Alaska LNG Liquefaction Plant Construction Permit
Application

**Information Reference Table for Alaska LNG
Liquefaction Plant**

ALASKA LNG	AGDC Response to ADEC Comments on the Liquefaction Plant Modeling Protocol	March 2018
	PUBLIC	Page 47

Figure A1: Light Extinction Contribution at Tuxedni between 2005 and 2013 on the Haziest Days

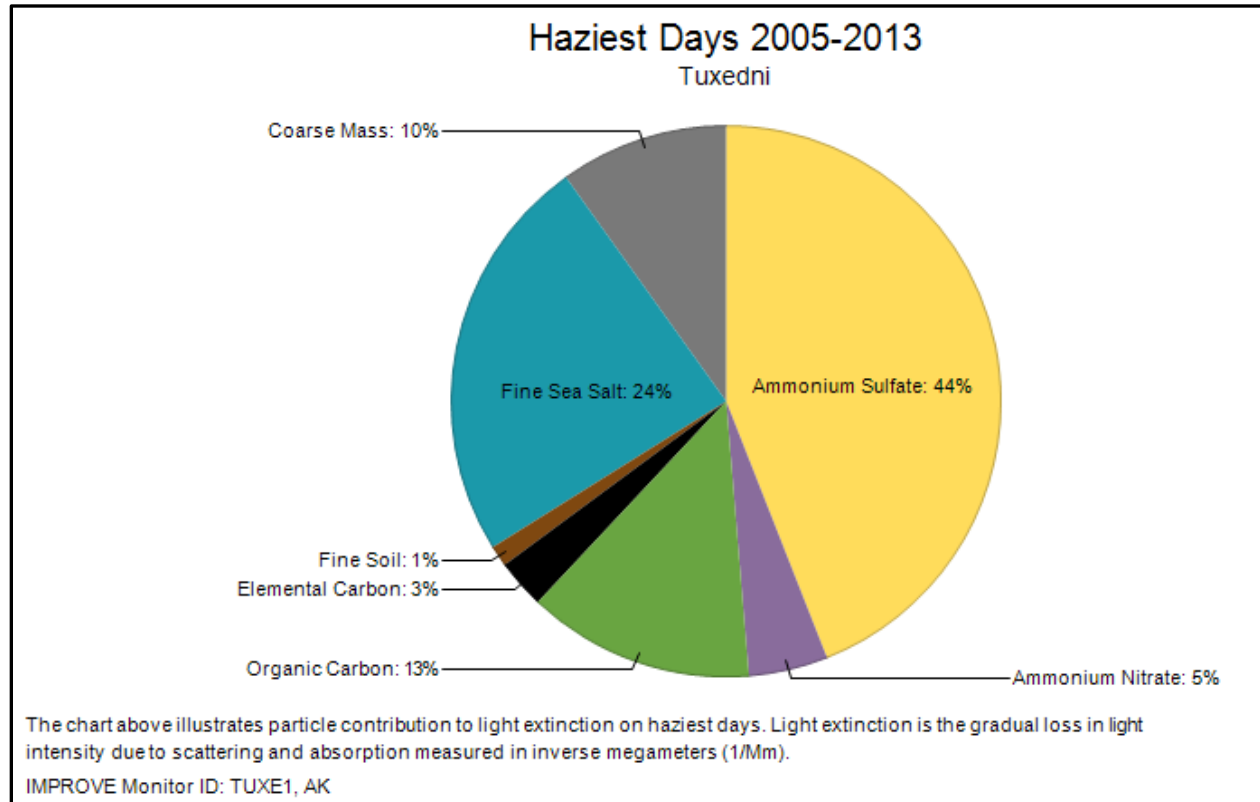
Comment: *The Department intends to review the ozone and secondary particulate impact analysis under the 2005 version of the Guideline, which is adopted by reference 18 AAC 50.040(f). It, therefore, encourages AGDC to reference and reiterate that the existing ambient ozone and PM-2.5 concentrations show that the AAAQS are not threatened. AGDC may also consider noting that the existing impact from secondary PM-2.5 formation is incorporated into the AAAQS demonstration through the use of local background data.*

This lack of sensitivity can be explained following a review of particle contribution to light extinction on the haziest days at Tuxedni and the sulfate-nitrate-ammonium system. Ammonium sulfate and ammonium nitrate are interrelated as the acidic sulfates and nitrates compete for available gaseous ammonia, a neutralizing base. Sulfates preferentially react with ammonia and the remaining ammonia is available for reaction to form ammonium nitrate. Thus, the formation of ammonium nitrate is dependent on the availability of ammonia, which is dependent upon the concentration of sulfate. It is not until all the sulfur is consumed that particulate production will shift to ammonium nitrate formation provided particle production is not limited first by ammonia. This situation is evident from Figure A1 which shows ammonium sulfate particles dominate ammonium nitrate particles on the haziest days at Tuxedni nearly 10 to 1.
